IDAP REPORT

Property:	4-6 Underwood Road HOMEBUSH
	DA 2020/146
	Change of use to a printing manufacturing facility,
Proposal:	alterations and additions to existing structures to
	form one building, ancillary landscaping.
Applicant:	M Sande
Owner:	Underwood Homebush P/L
Date of lodgement:	13 August 2020
Notification period:	24 August 2020 to 22 September 2020
Submissions received:	Two
Assessment officer:	P Santos
Estimated cost of works:	\$550,000.00
Zoning:	IN1 - General Industrial - SLEP 2012
Flood affected:	Yes
RECOMMENDATION OF OFFICER:	APPROVAL

Figure 7. Extract of the survey plan with the easement emphasised with red outline (source: Anthony & Associates Surveying, dated 10/09/2019)

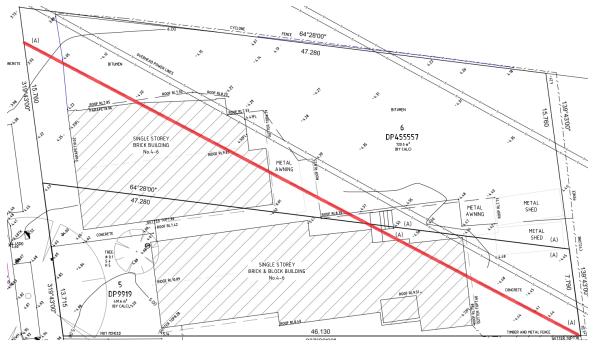
Pursuant to Clause 45 of the Infrastructure SEPP, the application was referred to Ausgrid. As a response, Ausgrid has provided the following conditions for any activies within the electricity easement:

- "All construction works on or near the easement and/or powerlines must adhere to the Safework NSW Work Near Overhead Powerlines: Code of Practice, 2006."
- "No vehicles, plant or equipment having a height exceeding 4.6 metres are to be brought into the easement site without written approval from Ausgrid."
- "Vehicles brought into the easement, with a height less than 4.6m but having an extension capable of extending greater than 4.6m above ground, must not have that extension operated at all whilst within the easement."
- "Adequate removable protection must be installed to prevent vehicles inadvertently colliding with the transmission tower. This proposed form of protection must be forwarded to Ausgrid for review and consent."
- "No buildings/structures or parts thereof constructed may encroach the easement."
